**SEWAGE
DISPOSAL
SYSTEM**

**COMMUNITY
CORRECTIONAL CENTER
Brooklyn, Connecticut**

ENVIRONMENTAL REVIEW TEAM REPORT
ON THE
PROPOSED SEWAGE DISPOSAL SYSTEM
STATE OF CONNECTICUT COMMUNITY CORRECTIONAL CENTER
BROOKLYN, CONNECTICUT
JUNE 1973

TANNER BROOK DRAINAGE BASIN

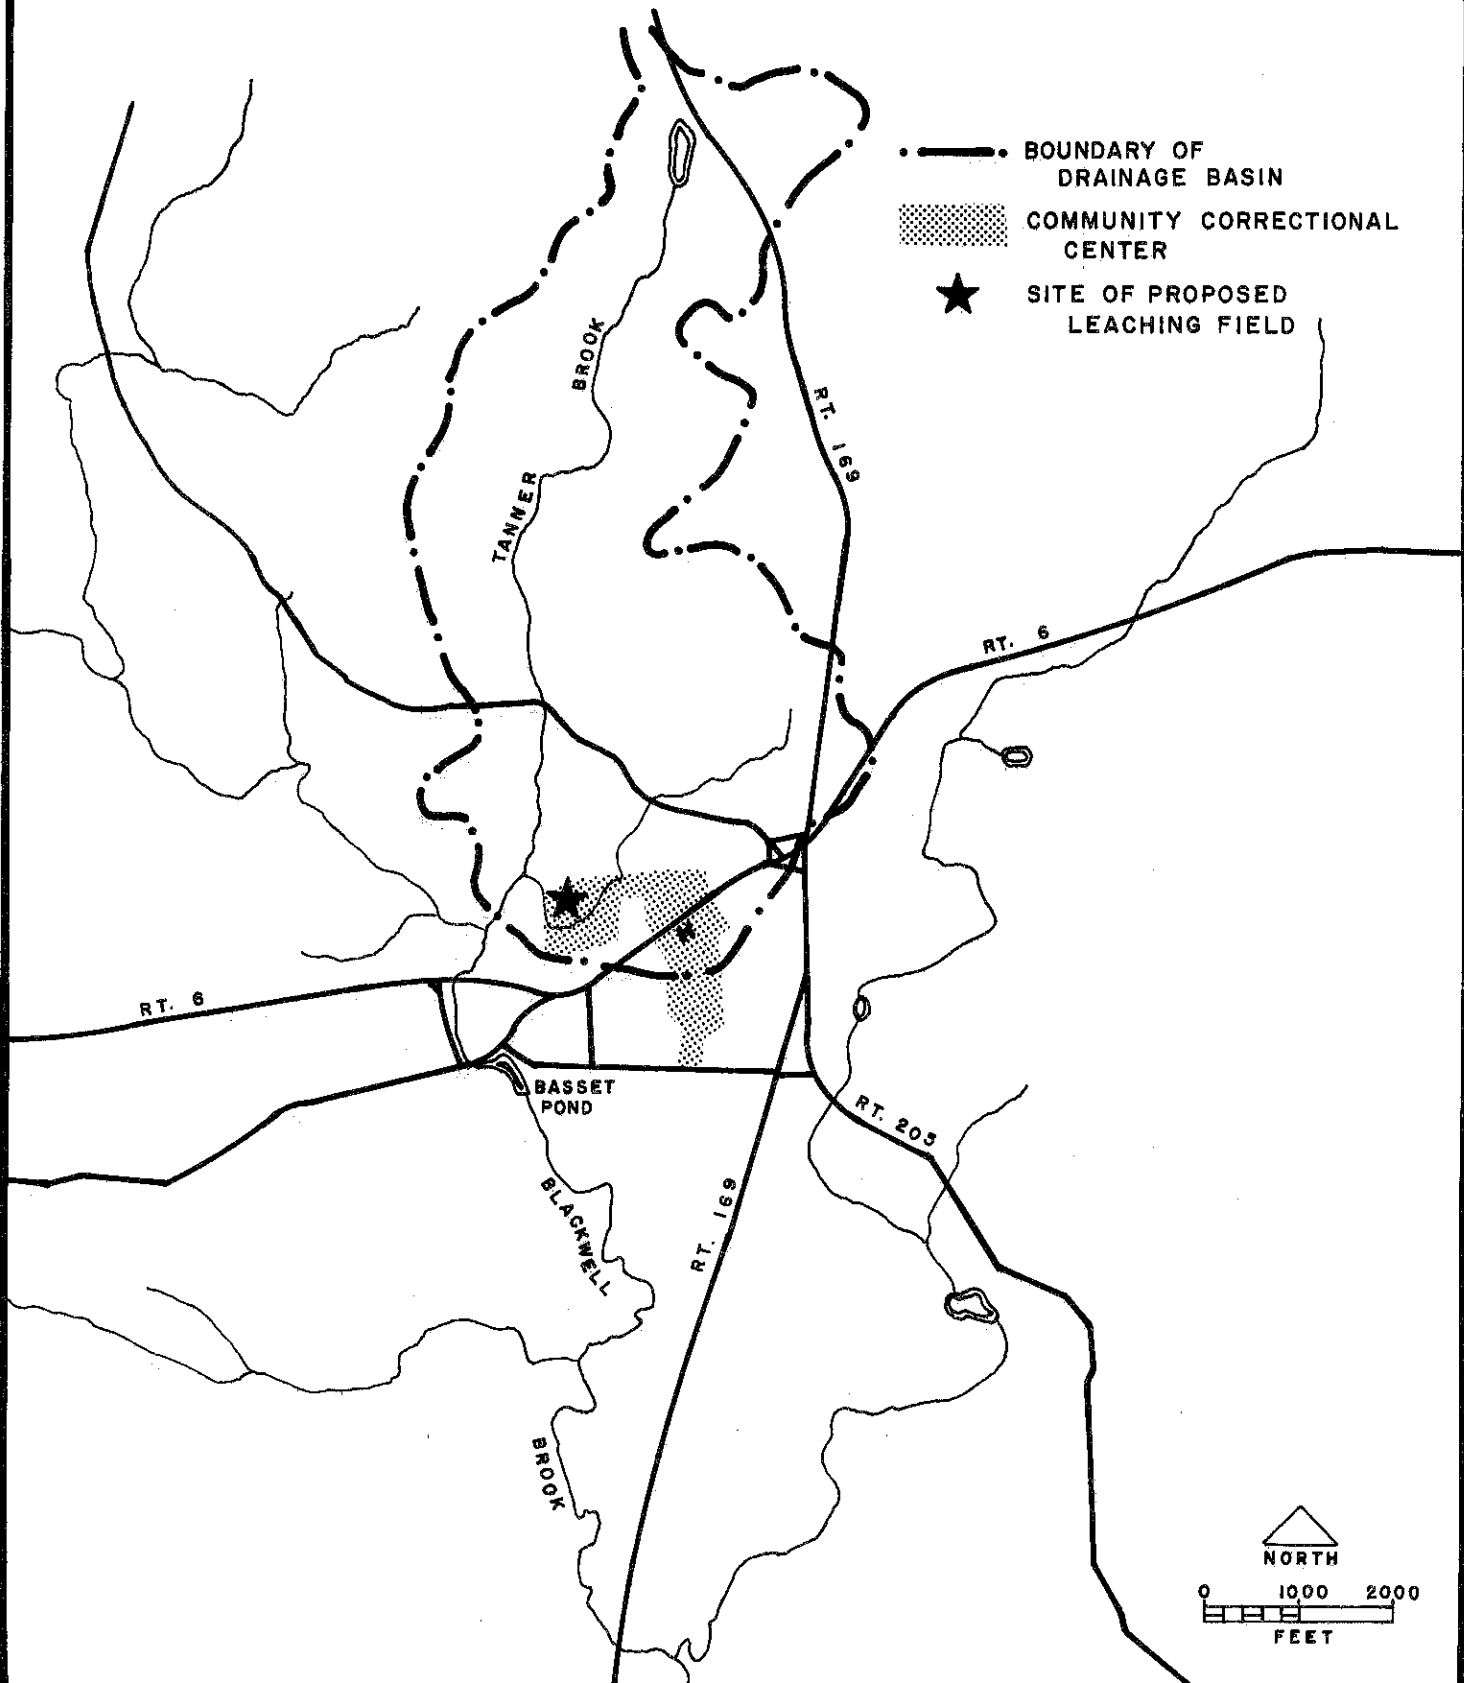
Pollution and eutrophication of the nearby waterways may result, unless there is sufficient water within the hydrologic system to maintain a safe dilution factor between the natural and man-induced fluids. To better visualize what the potential for pollution is at this site, if there is any, the low flow characteristics for the Tanner Brook drainage basin (see map on next page for area of drainage basin) were calculated using several methods.

The actual equations used to determine the low flow value for the Tanner Brook drainage basin are given in the appendix. By using various calculations, none of which particularly represent a correct numerical value, they all indicate that discharges from this area can be quite low several times a year. During years of average precipitation the natural low flow is approximately

43,000 gallons per day within the Tanner Brook drainage basin. Using this figure and the 10,000 gallon per day estimated effluent, the dilution ratio in average years should be approximately 4:1. In exceptional years where the low flow values are much lower, the dilution ratios can get down to 1:1 or even less.

If it is determined that the dilution ratios are insufficient to ensure the protection of plant and animal life of the Tanner Brook drainage basin, one alternative may be to relocate the proposed facility along Blackwell Brook. This drainage basin, which includes Tanner Brook, is much larger and would have a low flow dilution ratio of greater than 20:1, a much less critical setting for pollution.
